ARCHITECT'S ADDENDUM

Addendum Number: 002

RE: EASD #131 East Aurora High School
2027 Mechanical Improvements

Subject: Addendum No. 002 to the Construction Documents for the EASD #131 East Aurora High School 2027 Mechanical Improvements Project.

DRAWING TITLE:
AREA D - FIRST
FLOOR -
DEMOLITION PLAN
D-A1.41

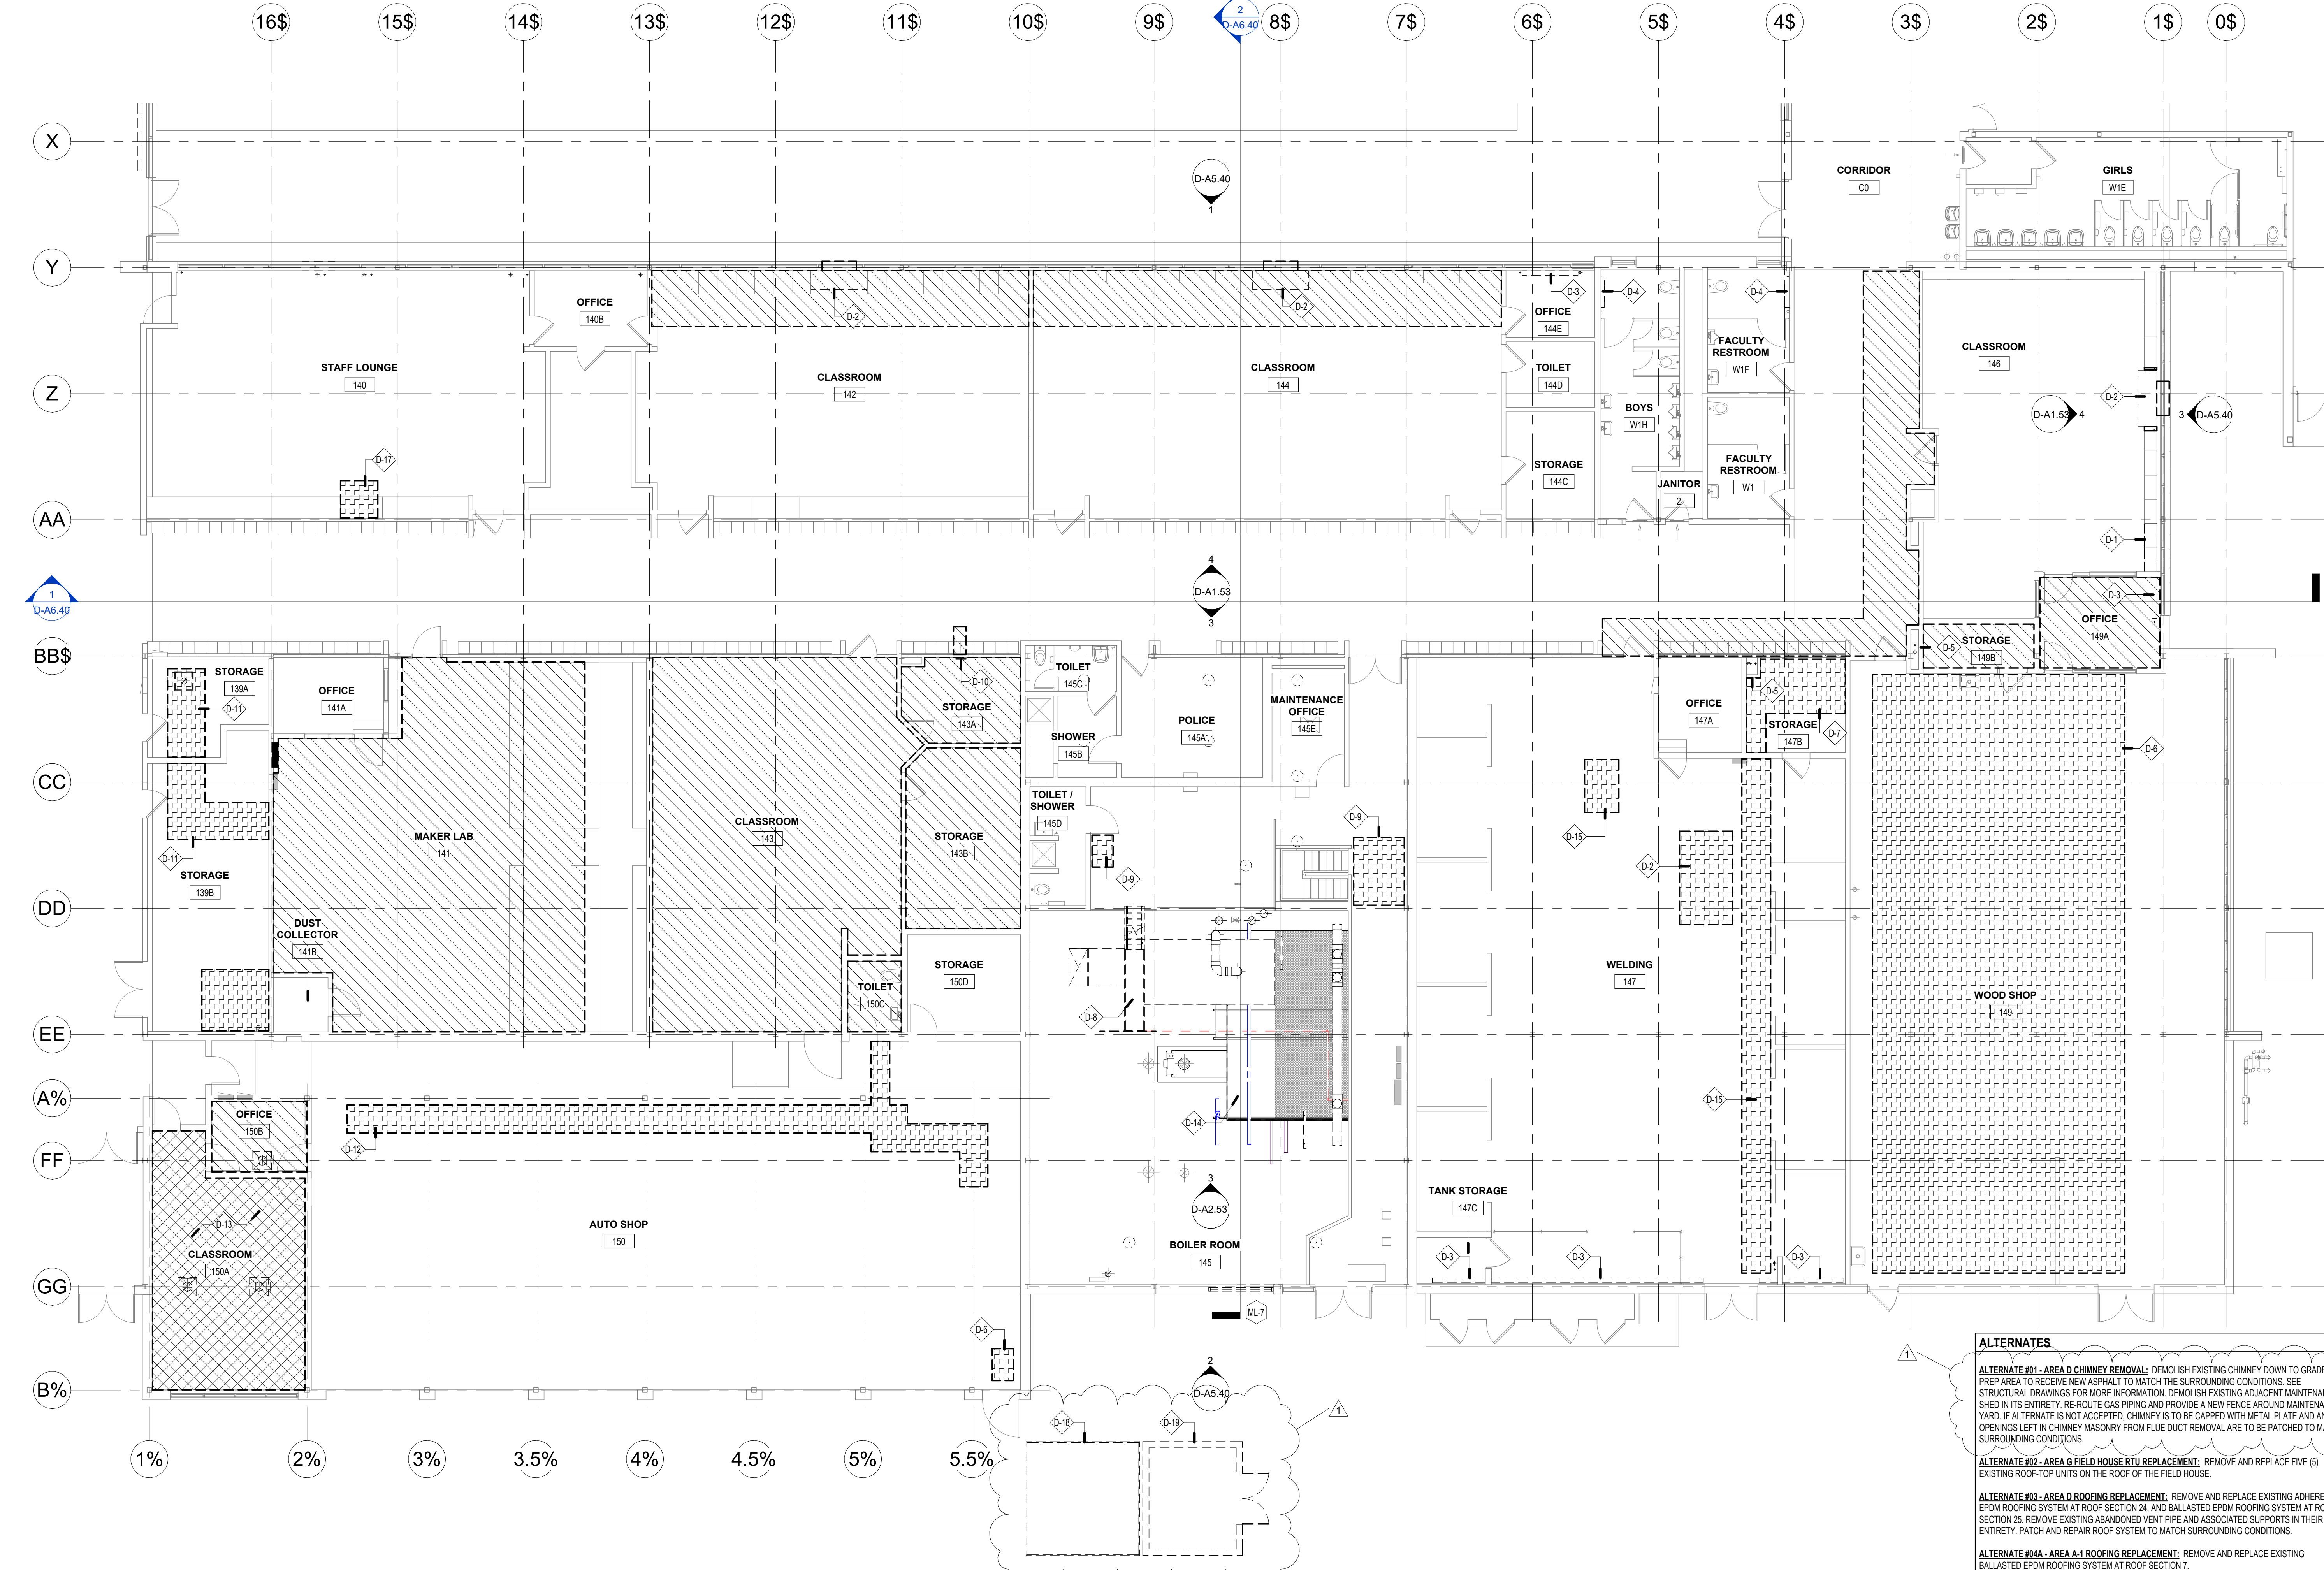
8. D-A1.41 – AREA D – FIRST FLOOR – DEMOLITION PLAN

- Demolition Keynote Clarifications are as follows, refer to revised drawings for more detail:
D18. Demolition of existing chimney noted with “D18” keynote.
D19. Demolition of existing maintenance shed noted with “D19” keynote.
